Subject: Revision 1 to Transnuclear, Inc. (TN) Application for Approval of the TN-LC Transportation Package, Response to Request for Supplemental Information (Docket No. 71-9358; TAC No. L24543)

**Responses to Request for Supplemental Information
(Non-proprietary Version)**

DOCKET NO. 71-9358REQUEST FOR SUPPLEMENTAL INFORMATION (RSI) FOR THE
MODEL NO. TN-LC PACKAGE

*Figure 6.10.2-6
Partially Filled Cavity*

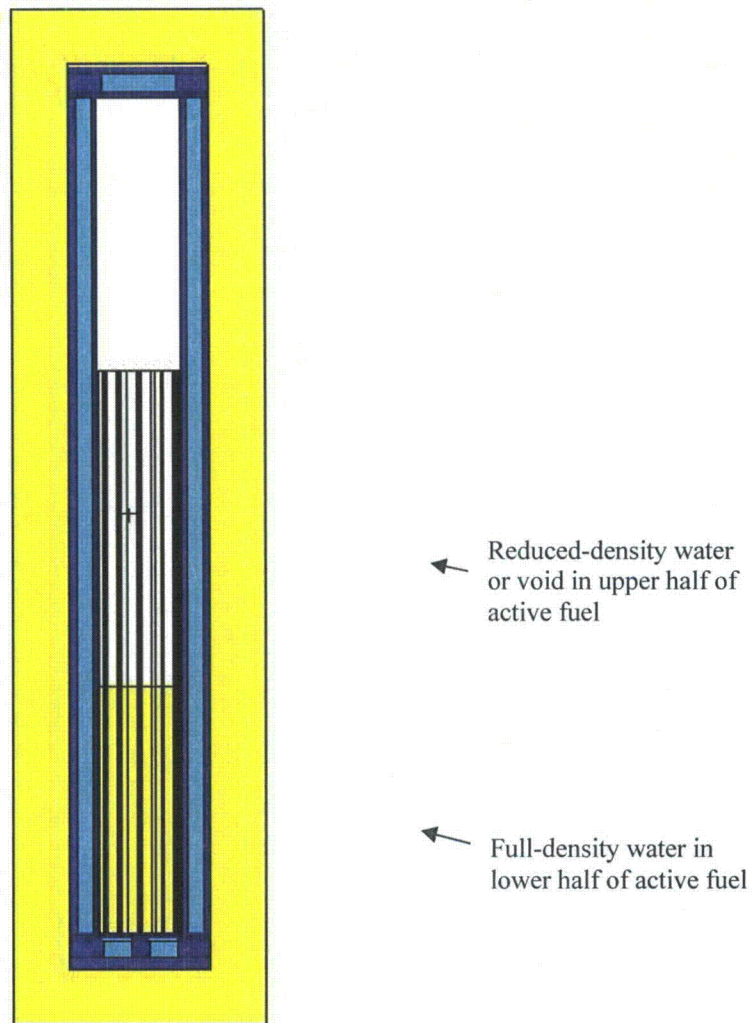
- RSI 12** Clarify whether partial and/or preferential flooding has been addressed for each of the four TN-LC basket designs (TN-LC-NRUX, TN-LC-MTR, TN-LC-TRIGA, and TN-LC-1FA). Demonstrate that partial and preferential flooding is less reactive than modeling flooding in all areas of the package at the most reactive density.

The TN-LC cavity and all baskets have been designed to drain freely. Therefore, preferential flooding that could result in a more reactive configuration is not credible for any of the baskets. However, the cavity could be partially flooded. Because the baskets drain freely, if the TN-LC cavity is partially flooded, the only credible scenario is that some fuel would be submerged in water, and the remaining fuel would remain unsubmerged. Therefore, any partial flooding scenarios would result in unmoderated fuel. All fuels transported in the TN-LC, including the HEU fuels, show lower reactivity in the absence of moderation. Therefore, any partial flooding would uncover fuel and decrease the reactivity. This effect is demonstrated explicitly for NRU fuel in Appendix 6.10.2 of the SAR.

A discussion on partial and/or preferential flooding is added to the criticality analysis for each of the four basket/fuel types – Appendix 6.10.1, Section 6.10.1.3.1 for TN-LC-MTR basket, Appendix 6.10.2, Section 6.10.2.2.1 for TN-LC-NRUX basket, Appendix 6.10.3, Section 6.10.3.3.1 for TN-LC-TRIGA basket, and Appendix 6.10.4, Section 6.10.4.3.1 for TN-LC-1FA basket.

*Figure 6.10.4-16
KENO Model of the Most Reactive Case with Poison Plate Bolt Holes*

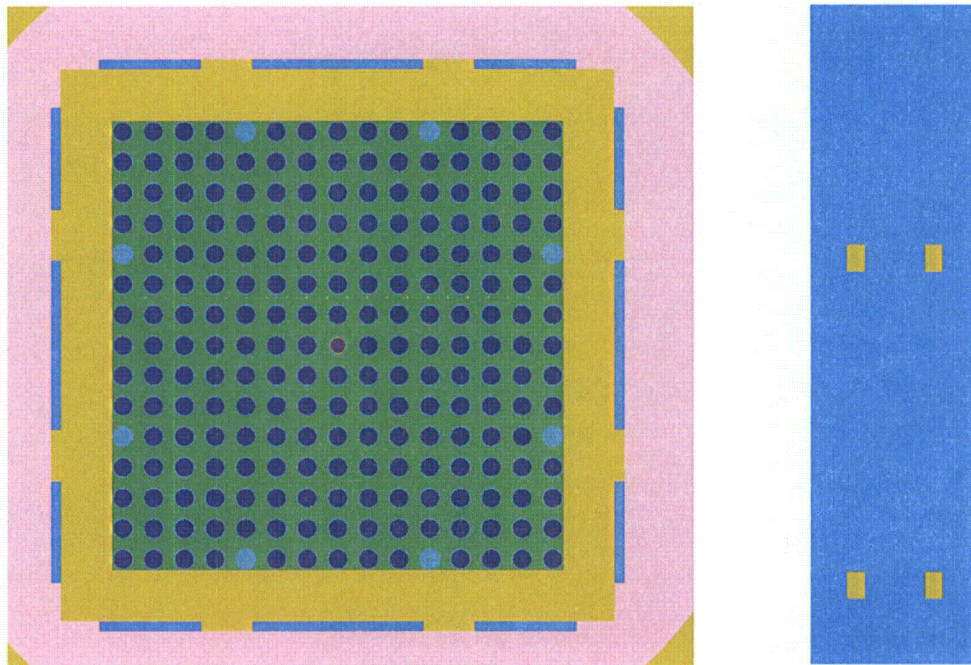
Note 12 on Sheet 1 of Licensing Drawing 65200-71-90 states that the poison plates can be made of multiple pieces of material.

Note 12 on Sheet 1 of Licensing Drawing 65200-71-90 statement is modified to "Each plate (Item 4) may consist of multiple segments in the longitudinal direction. Each segment must be attached by minimum of two studs (Item 3)."
